PROJECT: **HENGAM FERTILIZER PROJECT**

TITLE: **SEAL GAS PID CO2 COMPRESSOR(11-C-101)**

SCALE: N.T.S	OWNER PROJECT NO.: NA	VENDOR DWG. NO.:	REV.	SIZE:
SHT.: 1 OF 1	PIDECC PROJECT NO.: 1208	PIDECC DWG. NO.: VD-1208-301B-PID-406	04	A1

TITLE: **SEAL GAS PID CO2 COMPRESSOR(11-C-101)**

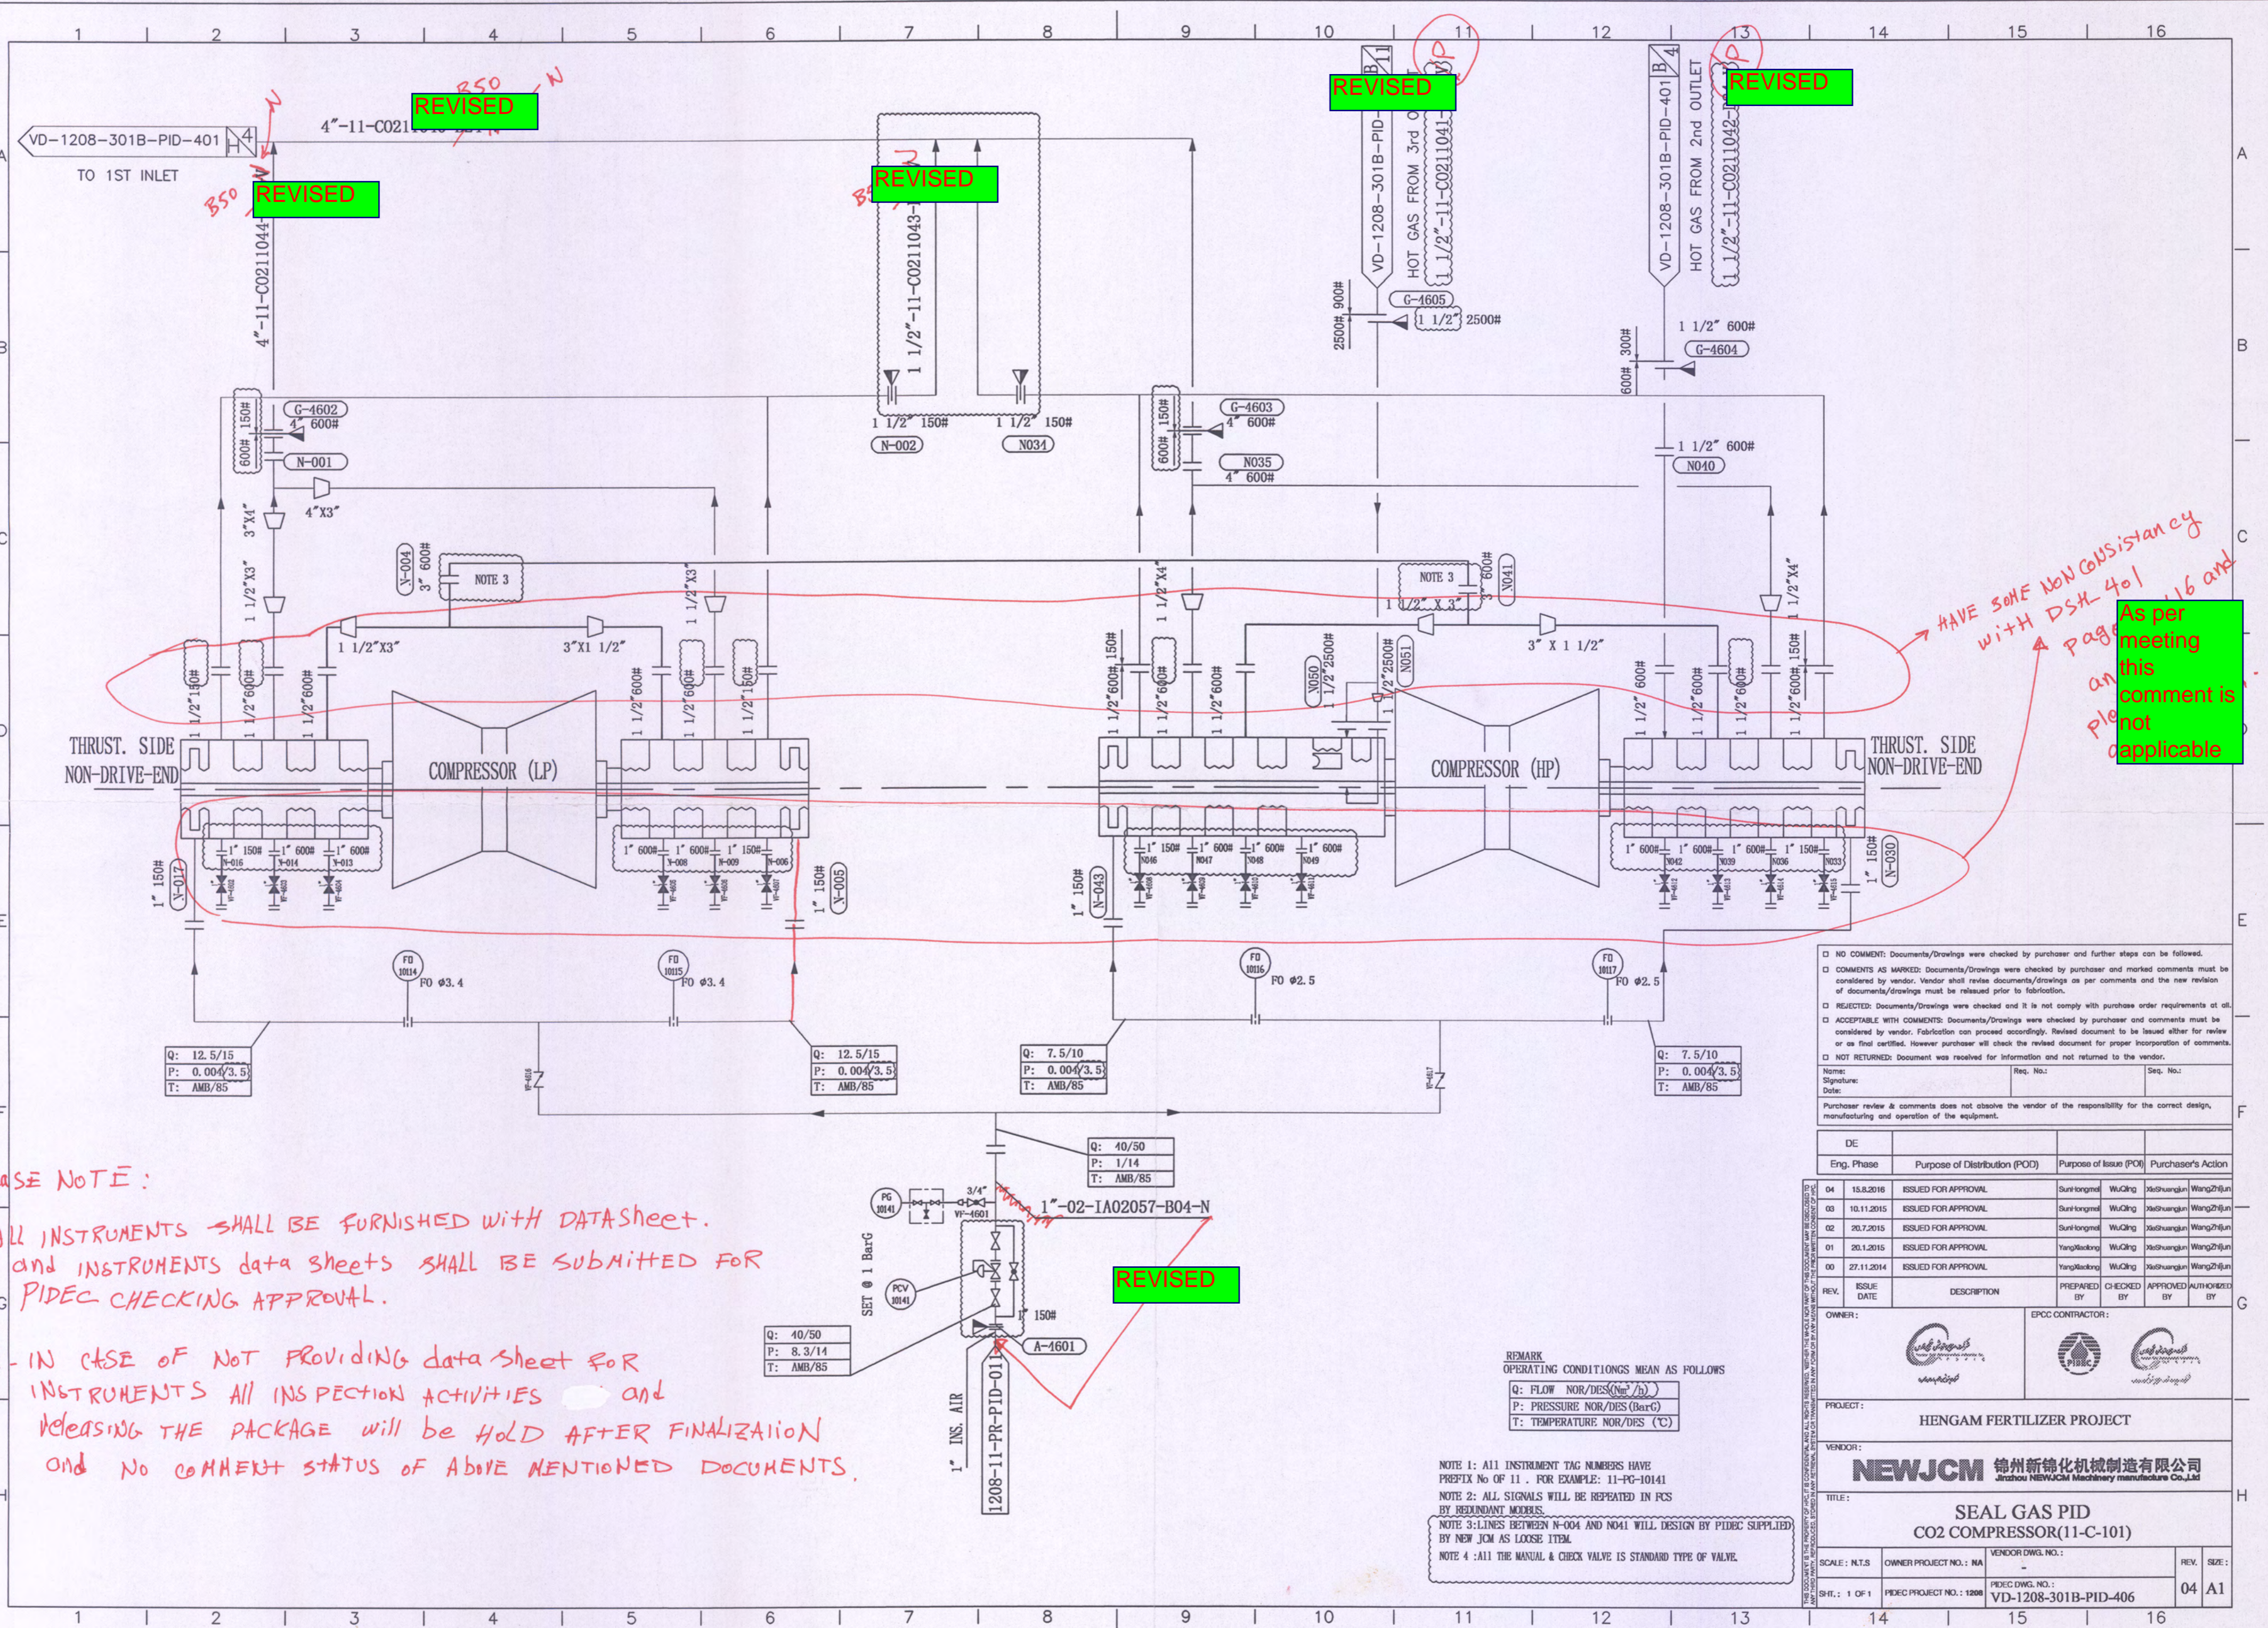
It is 2" in "VD-1208-301B-GAD-403". Please remove the inconsistency.
Revised

Refer to "CO2 On Skid Piping Arrangement" (last Rev.)
Not require to change

HAVE SOME NON CONSISTENCY WITH DSM-401
 page 16 and
 As per meeting this comment is not applicable
